### APPEAL SUMMARY

<b>Appeal ID:</b> 21956	<b>Project Address:</b> 1600 SW Salmon St
<b>Hearing Date:</b> 10/2/19	<b>Appellant Name:</b> Tom Jaleski
<b>Case No.:</b> B-016	<b>Appellant Phone:</b> 503.488.5651
<b>Appeal Type:</b> Building	<b>Plans Examiner/Inspector:</b> Jody Orrison
<b>Project Type:</b> commercial	<b>Stories:</b> 6 <b>Occupancy:</b> A-2, A-3, B, E, S-1 / A-5, S-2 <b>Construction Type:</b> I-B, II-B
<b>Building/Business Name:</b> Lincoln High School	<b>Fire Sprinklers:</b> Yes - Main Building; non-sprinklered Grandstands
<b>Appeal Involves:</b> Erection of a new structure	<b>LUR or Permit Application No.:</b>
<b>Plan Submitted Option:</b> pdf [File 1] [File 2]	<b>Proposed use:</b> High School

**Code Section** §1028.1.1.1 Space Under Grandstands and Bleachers

4 LINCOLN HIGH  
SCHOOL  
REPLACEMENT

A128A

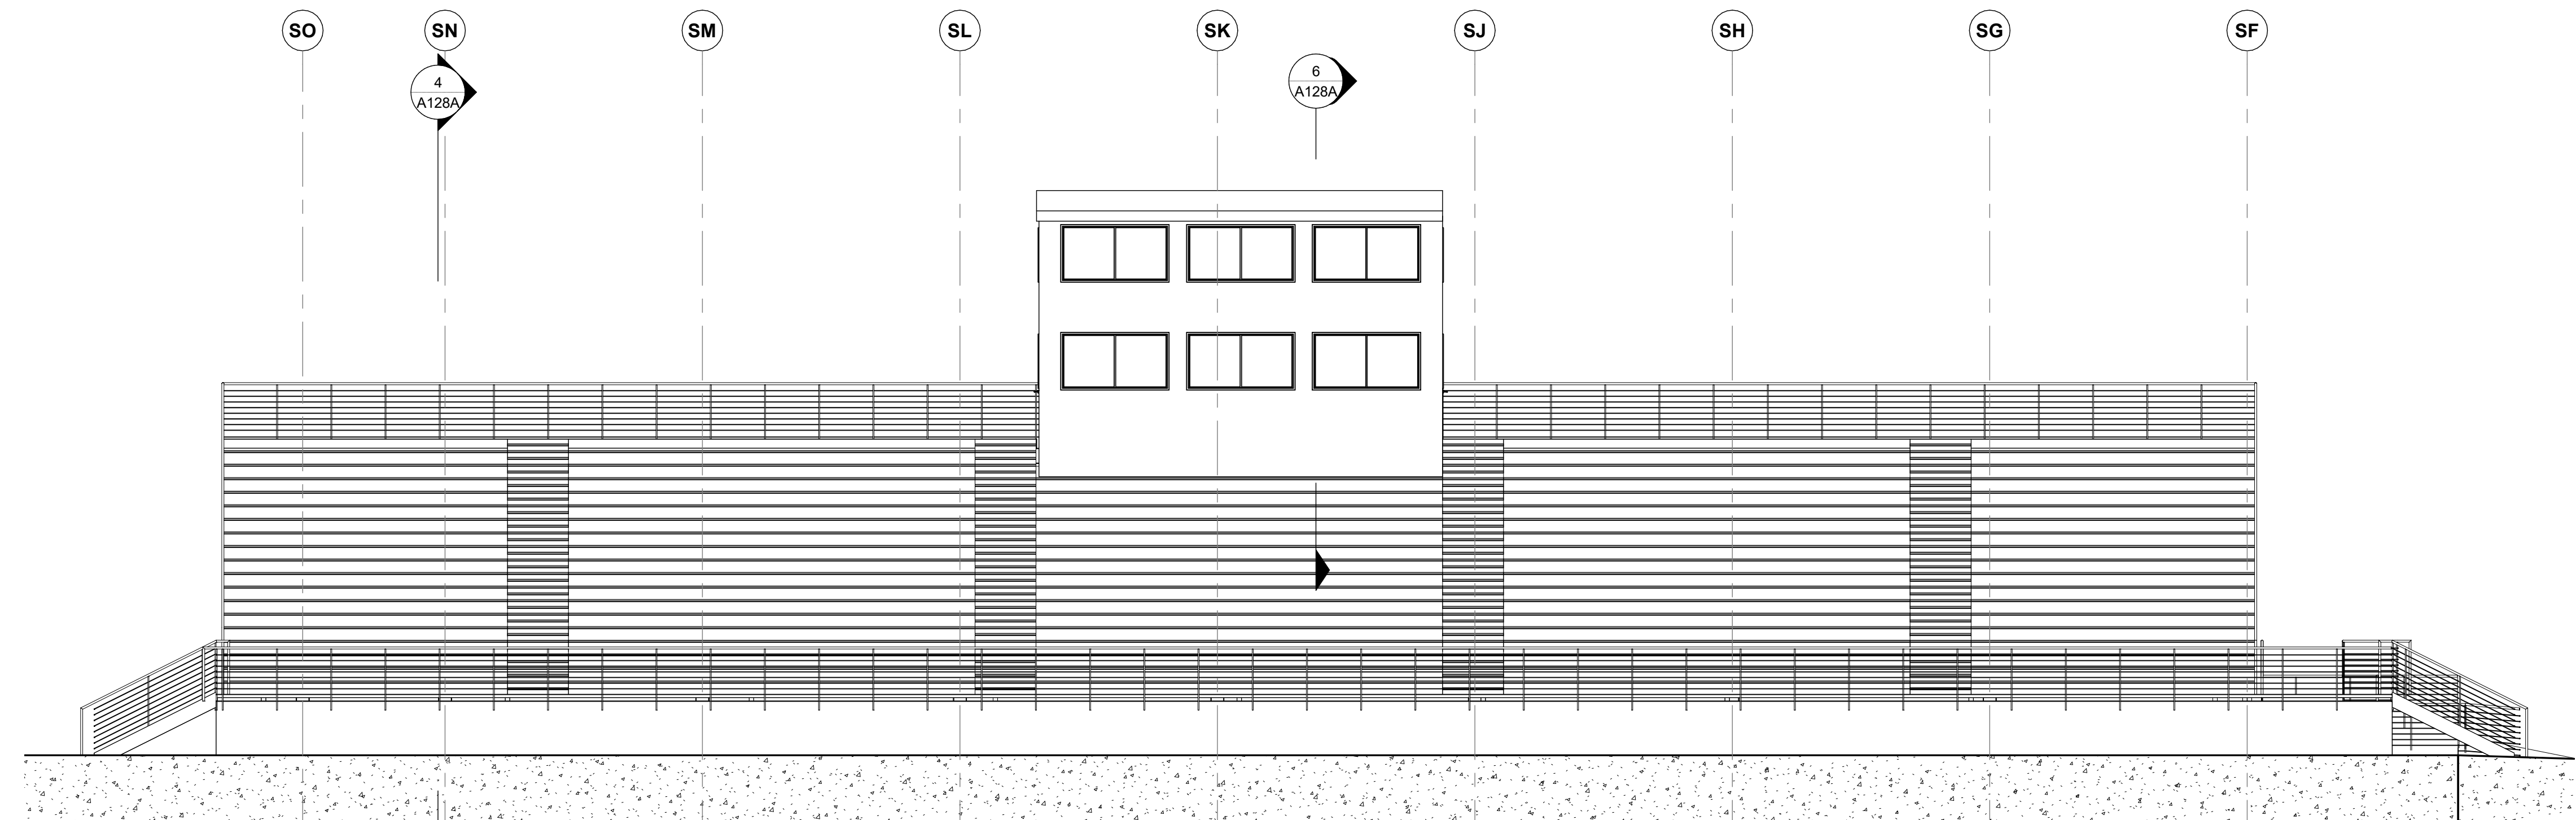
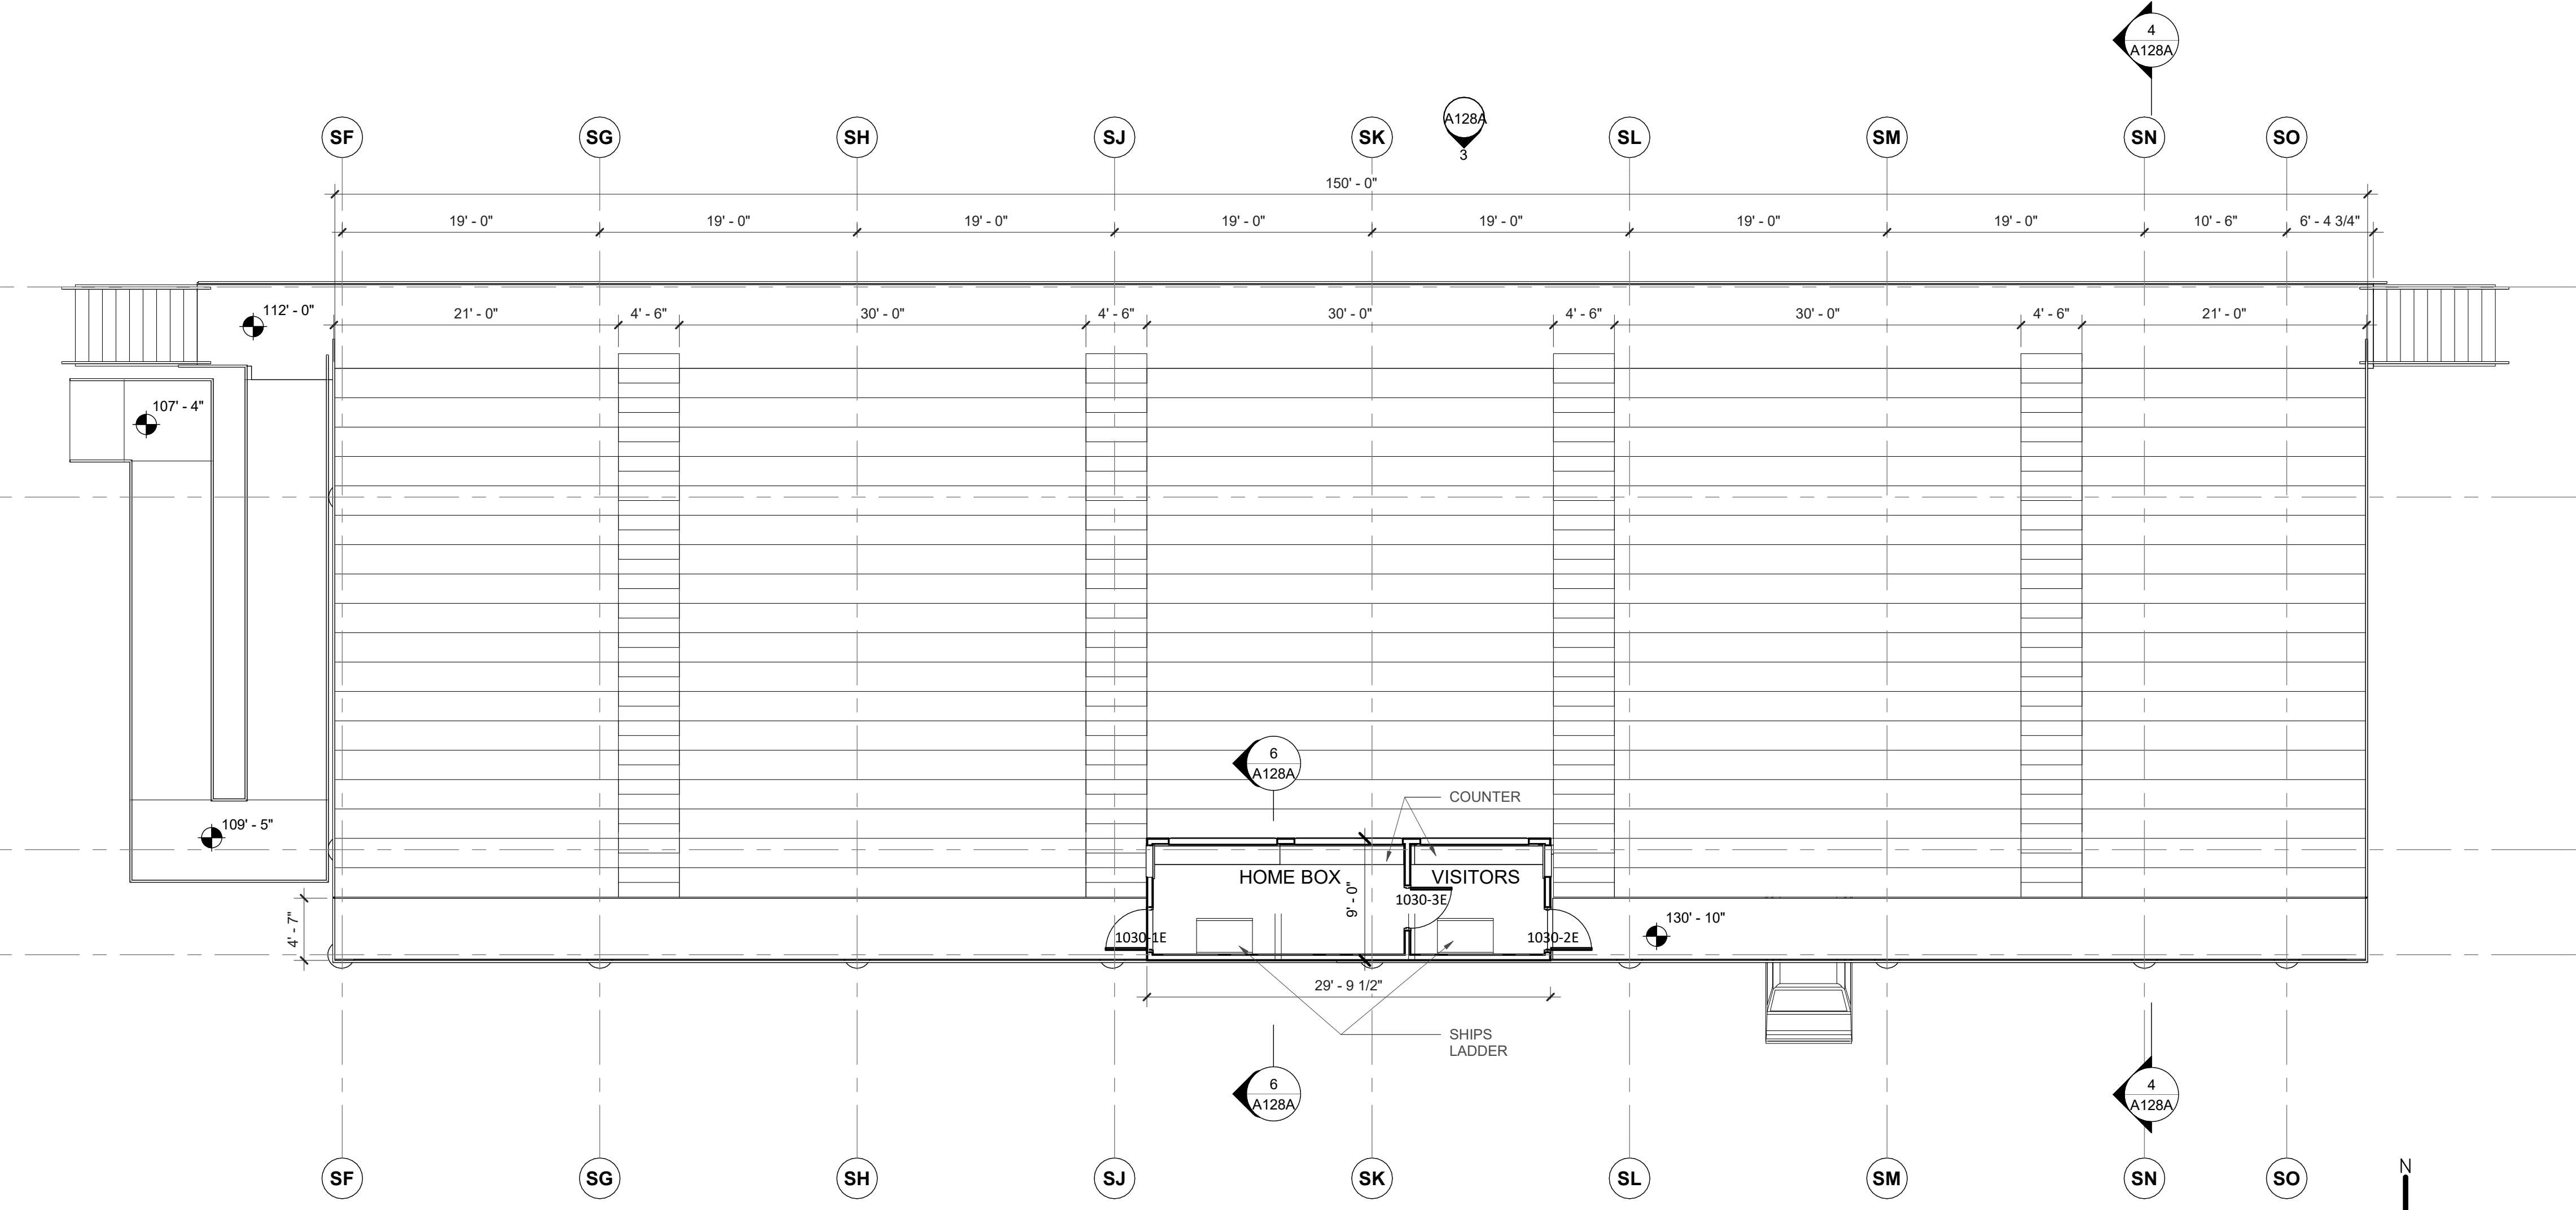
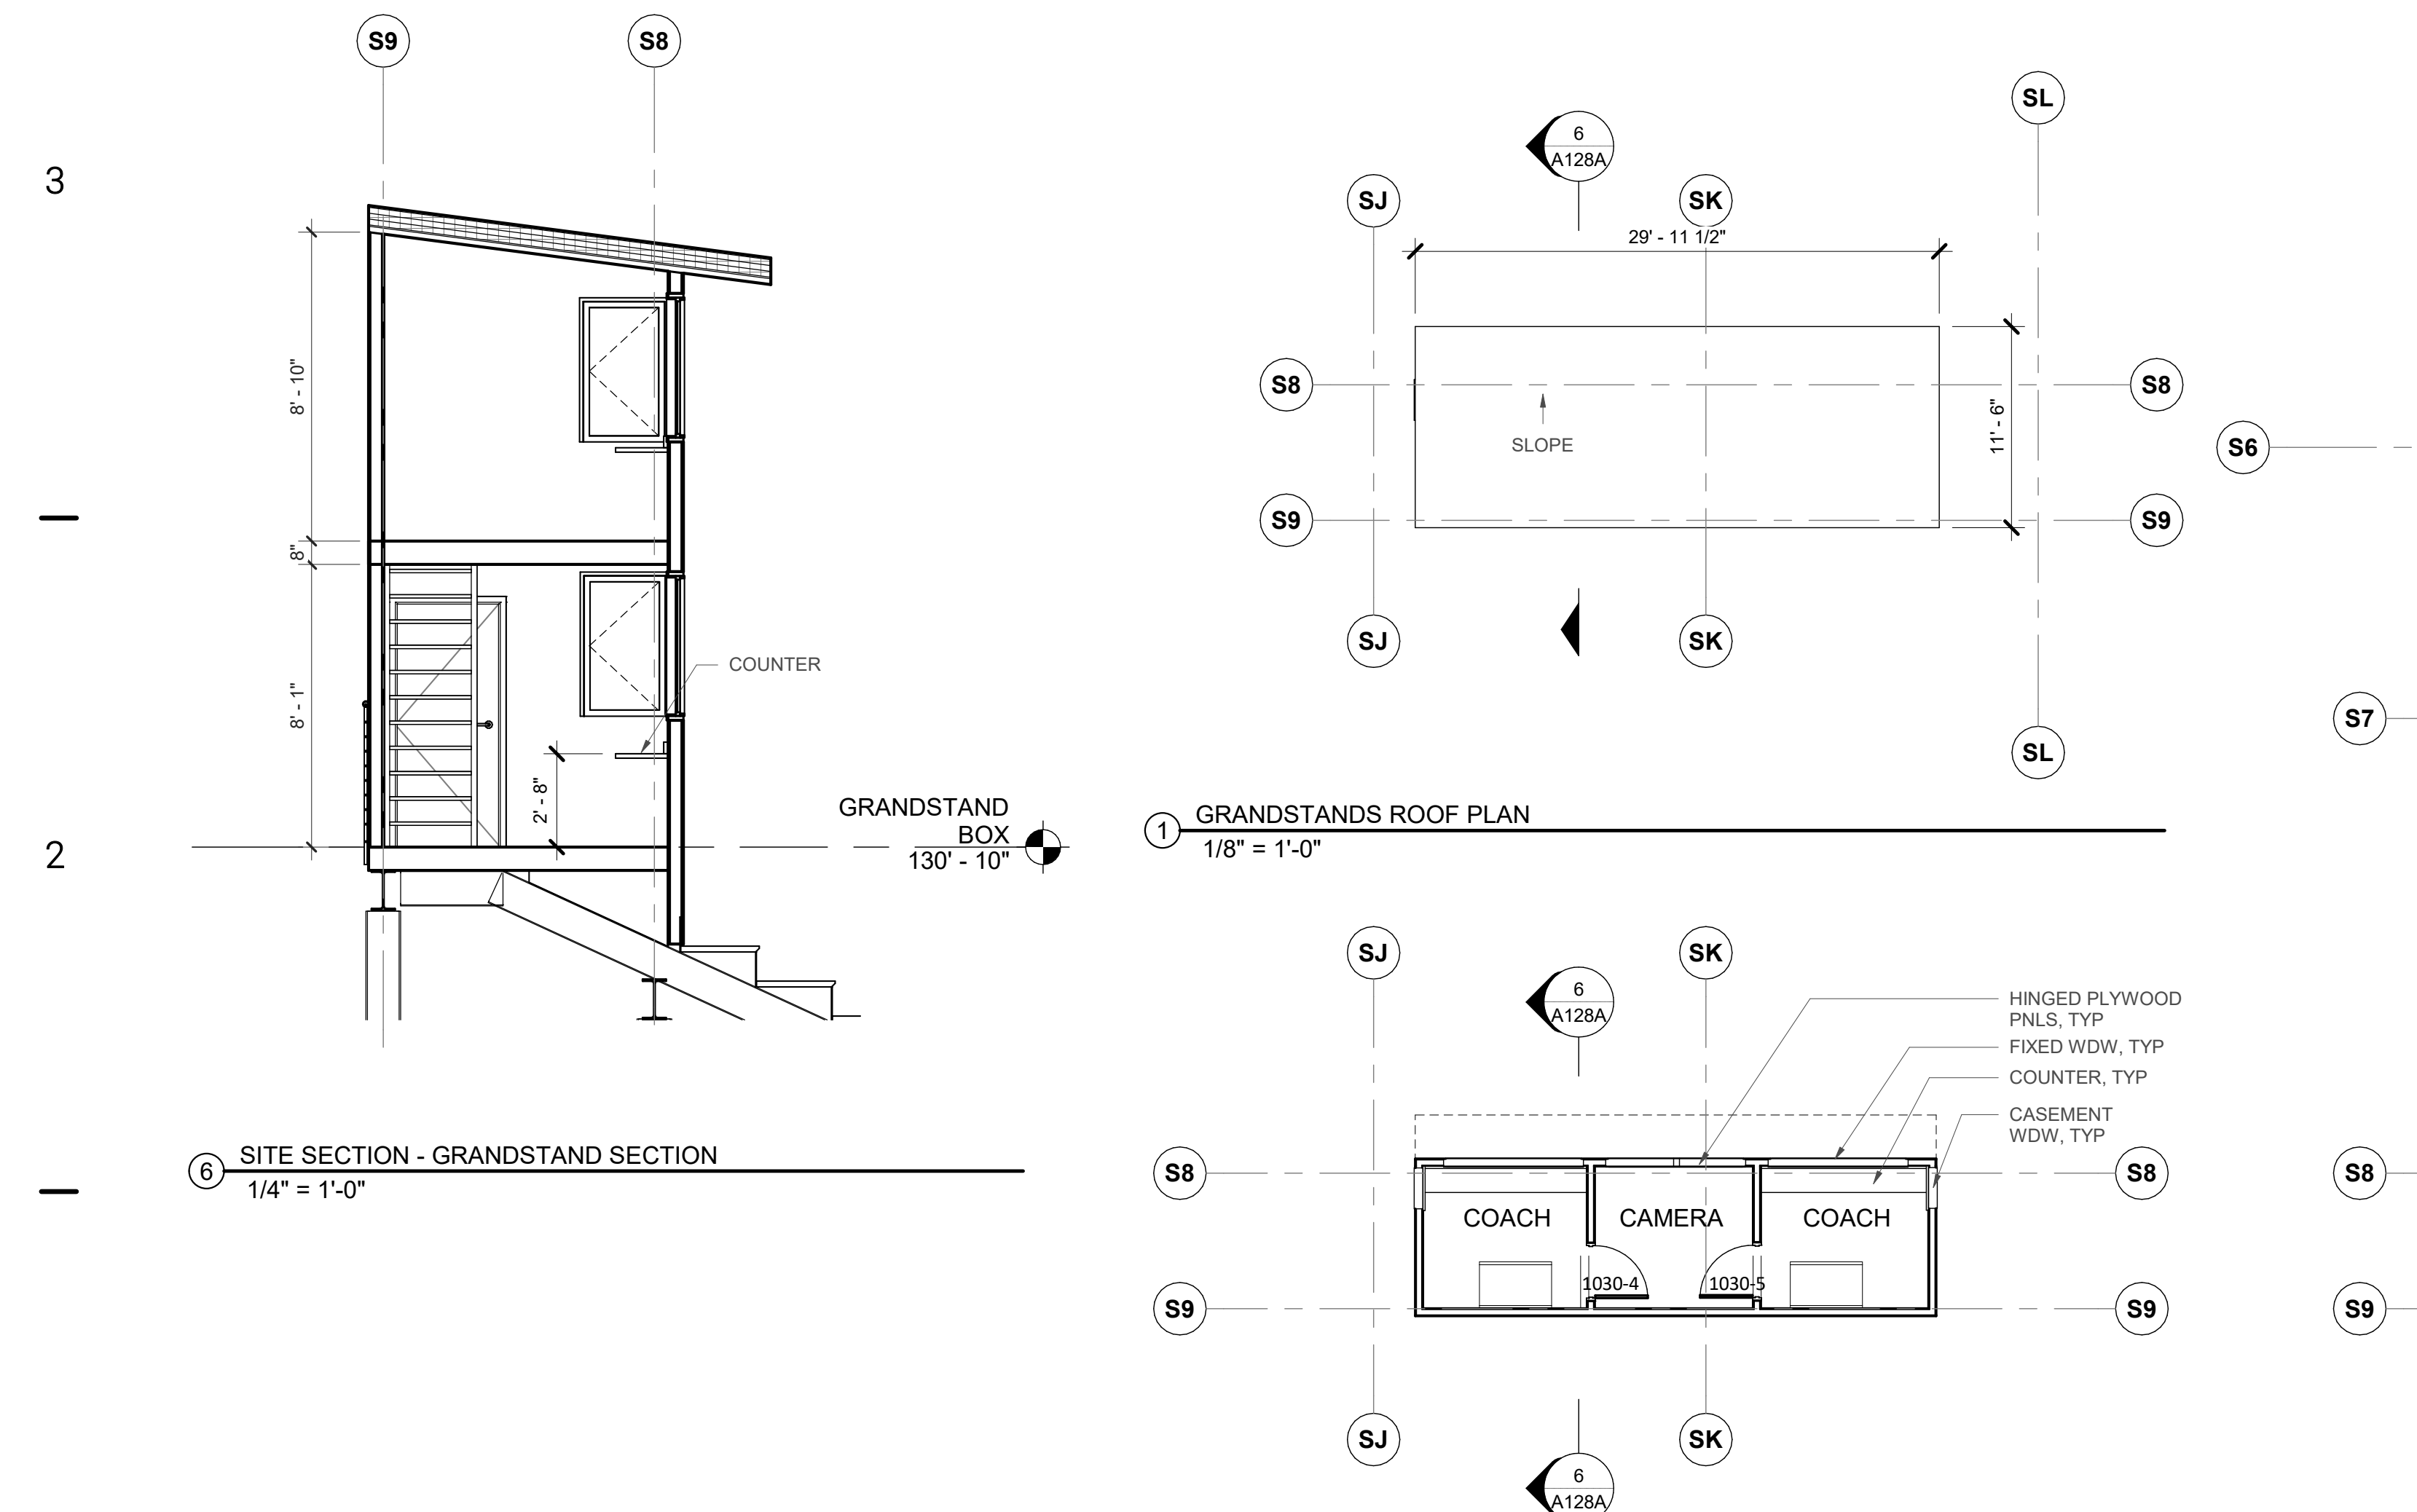
The southeast portion of the Lincoln High School site will include Grandstands positioned to view the track and field for sporting events. The proposed design of the Grandstands includes prefabricated aluminum bleacher seating with a press box and film deck stacked at the top tier. This portion of the structure classifies as A-5, while the parking below is Group S-2. The entire structure is proposed as non-sprinklered.

In addition, separation requirements for bleachers and grandstands assume that the bleachers are in a partially enclosed space with high-combustible storage surrounding and below; separation in this condition is typically provided at the ceilings and walls of the rooms below. Due to the exterior and very open installation of these Grandstands, however, the structure and the parking is unenclosed at three sides.

**2. Parking located beneath grandstand: Granted provided the parking area below the grandstands is limited to teachers during school hours 7:00AM – 5:00PM and provided the use of the grandstands is limited to after school hours and provided the District installs signs stating "NO PARKING DURING ATHLETIC EVENTS. VEHICLES WILL BE TOWED AT OWNERS EXPENSE" and provided a sign is installed at the entry gates stating "PARKING LOT TO BE FREE OF VEHICLES AND LOCKED DURING ATHLETIC EVENTS".**
